PREDETERMINATION SETTLEMENT AGREEMENT

CP# 01-18-71564
HUD# 07-18-8407-8

Description of the Subject Property

Fourth and Court consists of one building located at 420 Court Avenue. The residential floors of the building and common use / public areas will all be required to meet the same accessibility requirements of the ICRA and FHA. The building at Fourth and Court was issued a Certificate of Occupancy signed by Corey Christiansen, Building Official for the City of Des Moines, Iowa, on June 8, 2017.

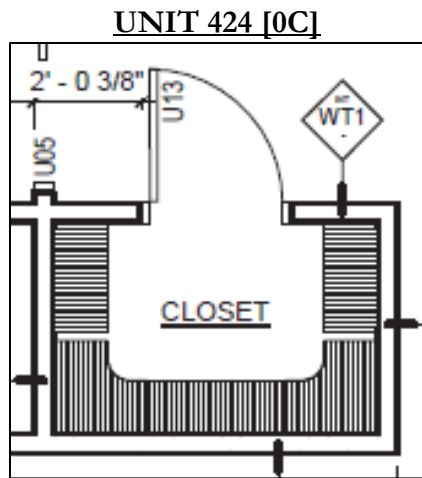
1) The mailboxes for all 81 units at Fourth and Court are housed within four wall-mounted mailbox units, which are located adjacent to the main entrance of the building. The building at Fourth and Court has an elevator. Therefore, the mailboxes for all units must meet reachability requirements.

There is sufficient clearance in front of all wall-mounted mailbox units to allow for a parallel approach by persons using a mobility-assistive device such as a wheelchair. The heights to the midline of the keyholes at the top four rows of mailboxes were measured, and are listed in the table below:

MAILBOX ROW	HEIGHT
Top	67 ½”
Second	64”
Third	60 ½”
Fourth	57 ¼”

The top four rows of mailboxes exceed the 54"-maximum allowed for a parallel approach by ANSI 1986, and render these mailboxes inaccessible.⁴

1) ICRC agrees with Respondents' (i) short-term proposal to notify tenants – who have mailboxes that are unreachable because they are too high – about their option to request to swap for a reachable mailbox with another tenant who is not disabled; and (ii) their long-term proposals to coordinate with the United States Postal Service (“USPS”) to retrofit the 32 mailbox compartments that are unreachable because they are too high such that these mailbox compartments will then have the midlines of the keyholes at heights of no greater than the 54”-maximum height allowed by the Manual, if at all possible within the space allowed in the common area. If the USPS and Respondents are not able to coordinate a solution in compliance with (ii) above then Respondents shall find another location within the common area to locate 32 new mailbox compartments in the Common Area and then relabel all mailbox compartments which do meet the 54” maximum height allowed by the Manual, leaving the top four rows of mailbox compartments, in place but not labeled and not for use by any tenant in the building.

ICRC will require this retrofit to be completed within 120 days from the date of the Closing Letter from ICRC. ICRC will require Respondents to notify current and future tenants occupying units that have mailboxes with unreachable heights assigned to them about the option to have a reachable mailbox assigned to them if they require it because of a mobility impairment.

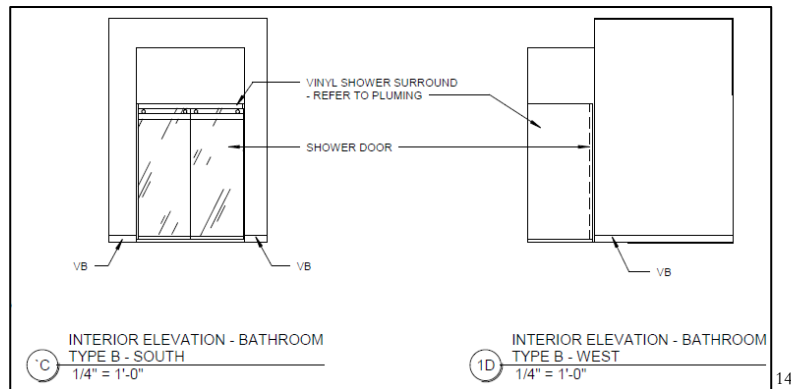
6) The plans submitted by Respondents include scaled drawings of the dwelling units. The relevant portion of the drawing for Units 216 [1D] and 409 [0A] are shown below:¹¹

Based on the scaled drawings above, the midline of the kitchen sink at Units 216 and 409 was designed to be about 30" away from the opposing counter. ICRC Investigators measured this distance in both units at 17".¹² The clearance from the midline of the sink to the opposing counter would have been

compliant with the 24”-minimum requirement as referenced above if installed according to the plans. But, as built, the kitchen sink is too close to the opposing counter, rendering it unusable by persons using wheelchairs.

5) ICRC agrees with Respondents' determination that the cabinet underneath the kitchen sink in Units 216 and 409 are removable – except for the portions of the wall behind the sink that are not painted – as based on the two photographs submitted showing the areas underneath and behind the sink with the cabinets removed. Therefore, ICRC determines that once all surfaces underneath and behind the sinks are finished, the kitchen sinks will be compliant with the 15"-minimum clearance requirement between the midline of the sink and the nearest obstruction because this clearance was measured by ICRC Investigators at 17", which is more than the minimum required.

ICRC agrees with Respondents' proposal to finish all unfinished areas underneath and behind the removable kitchen sinks – including flooring and walls – to meet FHA and ICRA requirement as stated in the Manual. ICRC will also require Respondents to verify the same surfaces underneath and behind the kitchen sinks are finished in all units with similar floor plans as Units 216 and 409, as reported in the table on page 3 of the current agreement.
